# Technical Service Information

## **VOLVO "850" 50-42LE SLIPPING OR "NO" FORWARD ENGAGEMENT**

Figure 1

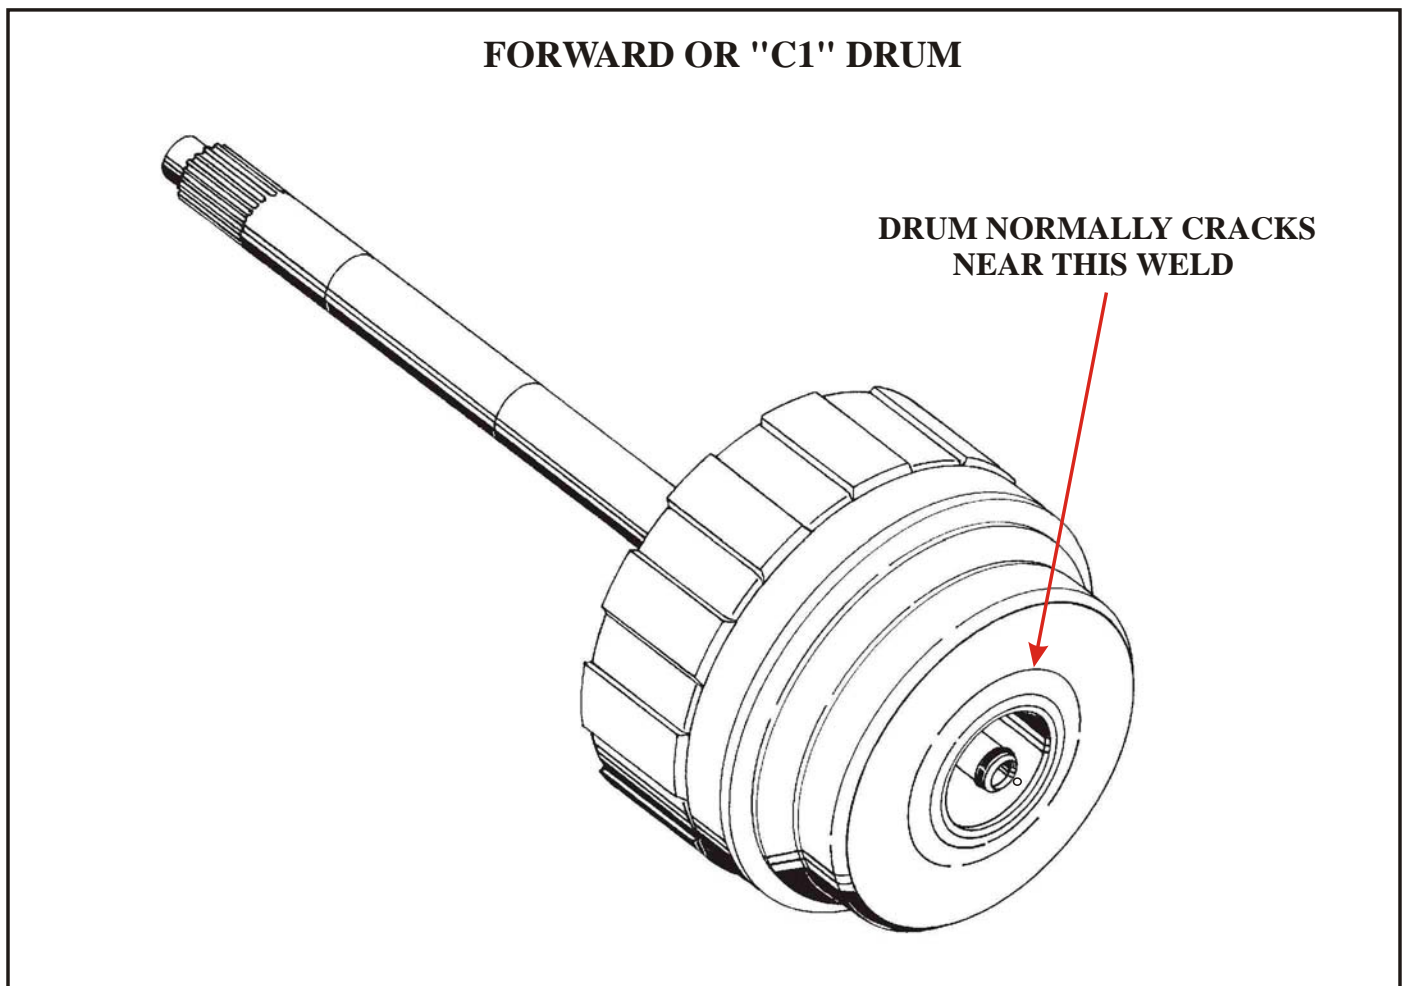
**COMPLAINT:** Volvo "850" series equipped with 50-42LE transmissions may exhibit a slipping or "NO" forward engagement condition.

**CAUSE:** The cause may be, the forward or C1 clutch drum is cracked (See Figure 1).

**CORRECTION:** Locate the crack as shown in Figure 1 and have the drum welded on the inside as well as the outside of the drum. At the time of this printing, the forward or C1 drum is not sold separately from the transmission.
